PROCESS SHEET

Customer	CU-DAR001 Dart Helicopters Services	Drawing Name	FWD TUBE ASSEMBLY
Job No.	27677	Part No.	D3391021
Estimate No.	10467	Drawing No.	D3391 REV E
P.O. No.	N/A	Drawing Rev.	E
First Issue	1/1	Project No.	N/A
Prsht Rev.	NC	Material	N/A
This Issue	6/23/2006	Due Date	7/30/2006
Prev. Run	27676	QTY:	1
Type : MACHINED PARTS

DART AEROSPACE LTD		Work Order:	
Description: Float Skidtube (412)		Part Number:	D3391-1
Inspection Dwg: D3391	Rev: E	Page 1 of 1

Subject: RE: D3391-1 out of tolerance

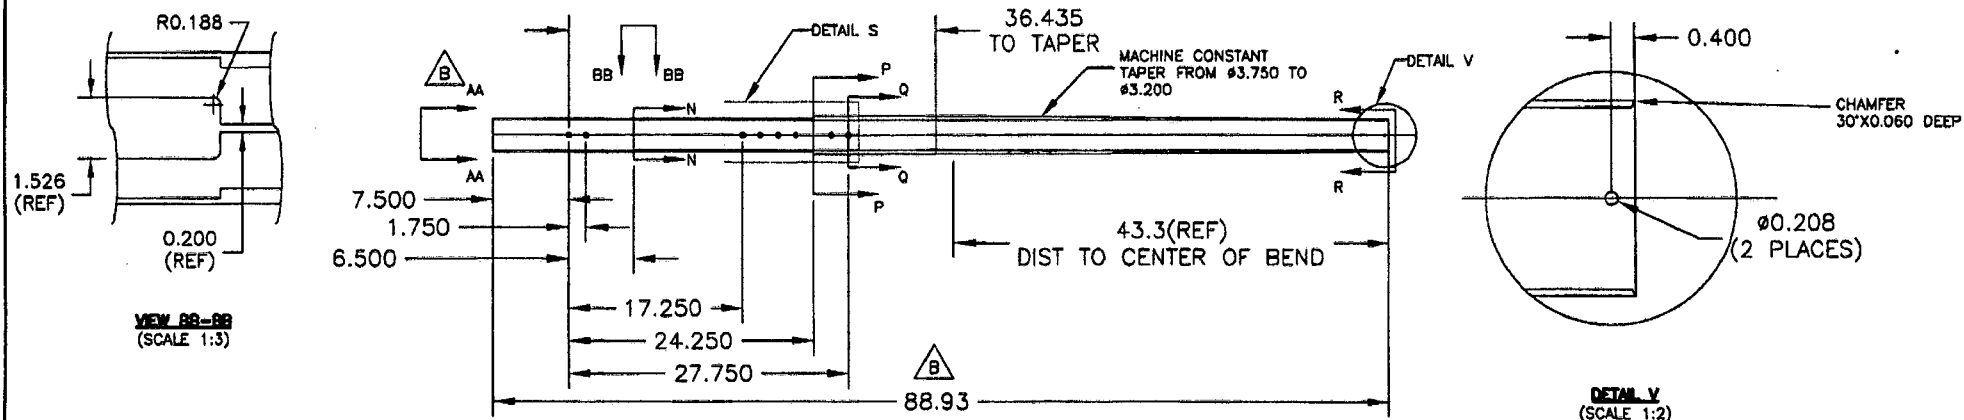
I've attached a picture showing the dimension 1.500" being out of tolerance. The measured dimension is 1.460". Therefore, the piece is 0.040" below nominal dimension

I think this part may become scrap because more bending moment will be introduced to the mid tube (D2500-1/-3) section. Previous testing has shown that a shorter tube will fail quicker than a longer tube.

I agree with you that there will be increased bending stress in the mid tube. However, I think there will be very little difference in the magnitude of this stress because of the 0.040" difference in length. My gut feel is that we should accept this part as a deviation.

Of course, you are always welcome to scrap it, but I don't think that it is necessary.
